UNITED STATES PATENT AND TRADEMARK OFFICE

APPLICATION NO.	FILING DATE	FIRST NAMED INVENTOR	ATTORNEY DOCKET NO.	CONFIRMATION NO.
10/773,252	02/09/2004	Mark Alan Etter	54525.000105	7155
21967	7590	01/20/2006	EXAMINER	
HUNTON & WILLIAMS LLP INTELLECTUAL PROPERTY DEPARTMENT 1900 K STREET, N.W. SUITE 1200 WASHINGTON, DC 20006-1109			WEEKS, GLORIA R	
		ART UNIT		PAPER NUMBER
		3721		
DATE MAILED: 01/20/2006

Office Action Summary	Application No.	Applicant(s)	
	10/773,252	ETTER ET AL.	
	Examiner	Art Unit	
	Gloria R. Weeks	3721

Figure A

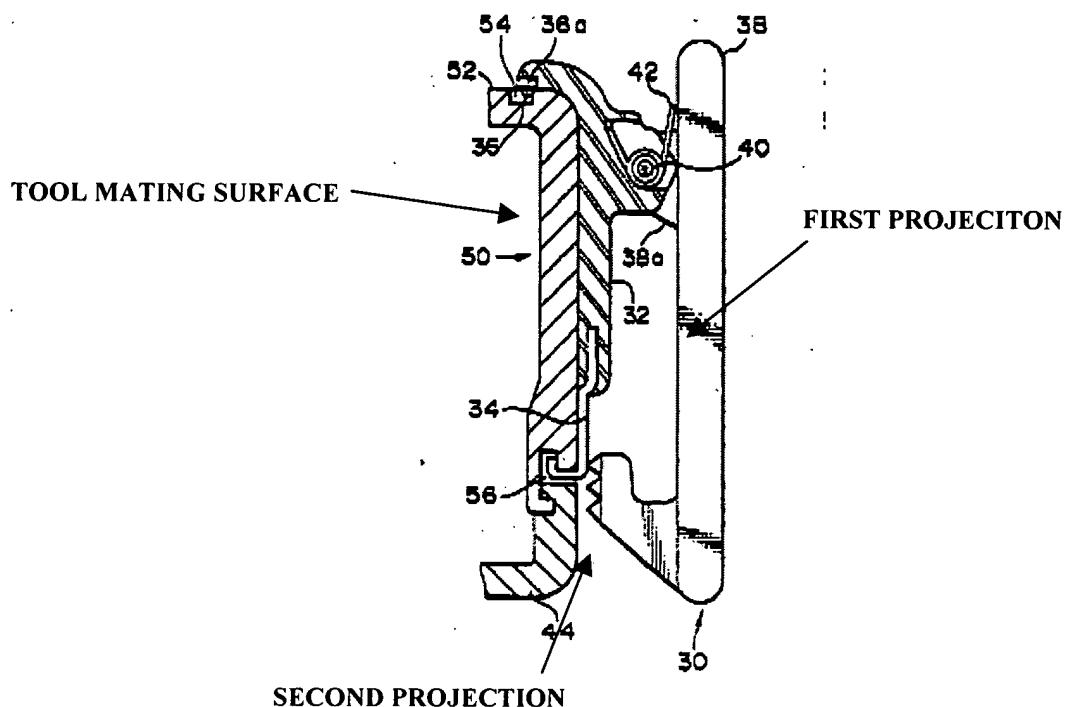
With respect to claim 8, Maurer et al. discloses a hand held power tool having a clip (10), wherein the clip (10) comprises: a tool mating surface (opposite 18); a first projection (14) extending outwardly from the tool mating surface at a first end, but does not disclose a second projection extending from a second end of the first projection. Hayasaka teaches a hand held device (50) having a clip (30), wherein the clip comprises: a tool mating surface (32); a first projection (38) extending outwardly from the tool mating surface at a first end, and a second projection (Figure A below) extending from a second end of the first projection. It would have been obvious to one having ordinary skill in the art at the time of the invention to modify the clip of Meurer et al. to include the second projection of Hayasaka for the purpose of providing a gripping engagement or to enclose the receiving space created by the tool mating surface and the first projection, thereby securing the hand held device to a surface.

In reference to claims 10-12, Meurer et al. discloses a hand-held power tool comprising: a housing (100) having a fastener receiving recess (102); a clip (10) detachably mounted to the housing (100) through attachment of a threaded clip fastener (threaded connecting portion of air hose at 102) to the fastener receiving recess (102), the clip fastener being selectively detachable and reattachable by a user to the fastener receiving recess (102). Meurer et al. does not disclose an indexing projection and an indexing projection recess. Hayasaka teaches a housing (50) and a detachable clip (30), wherein an indexing projection 36) extending from the clip (30) is received in an indexing projection recess (54) of the housing (50). It would have been obvious to one having ordinary skill in the art at the time of the invention to modify the housing and clip of Meurer et al. to include the indexing projection and indexing projection recess of Hayasaka, for the purpose of properly positioning the clip on the housing.

Grieg

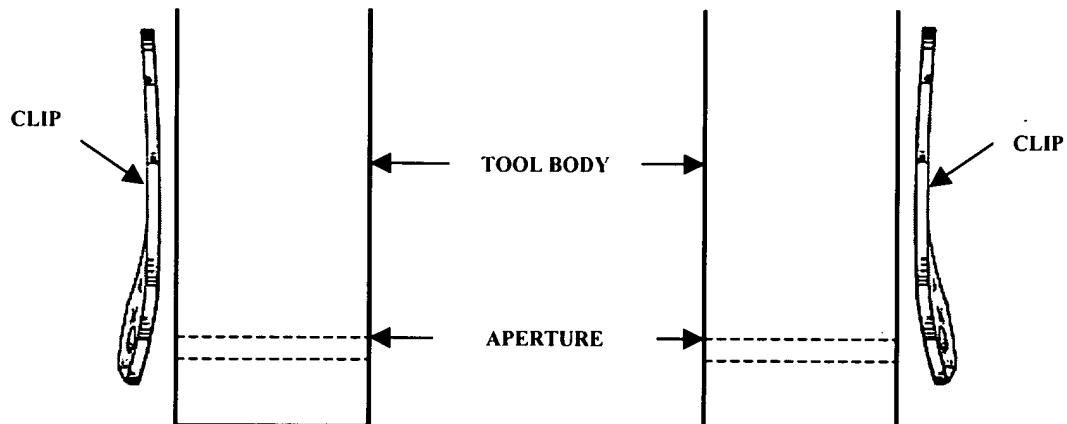
Applicant has not found Greig to teach or suggest attaching a clip at a second position using a second attaching means without the use of a first attaching means of a first position. Examiner agrees, that Greigh does not specifically illustrate attaching the clip in a second position, however, the structure provided by Greigh is fully capable of attaching a clip at a second position (see illustration below), and it is found obvious to do so for the purpose of accommodating a left-handed or right-handed operator.

Additionally, Applicant has also argued that there is no suggestion or motivation to combine Greig with the teachings of Shaw. The examiner recognizes that obviousness can only be established by combining or modifying the teachings of the prior art to produce the claimed invention where there is some teaching, suggestion, or motivation to do so found either in the references themselves or in the knowledge generally available to one of ordinary skill in the art. In this case, Greig disclosed a clip capable of being positioned on either side of a tool housing via through holes formed in the tool housing, thereby allowing the operator to use the same first and second attachment means in both positions. Examiner relied on Shaw for teaching that it is known in the art of power tools to attach a clip using either a through or non-through aperture, as the apertures are art recognized equivalents for the purpose of securing an attachment to a surface. Thus, one of ordinary skill in the art would have found it obvious to replace the through holes of Greig with the non-through holes of Shaw, thereby providing separate pairs of holes on either side of the housing to accommodate the clip.
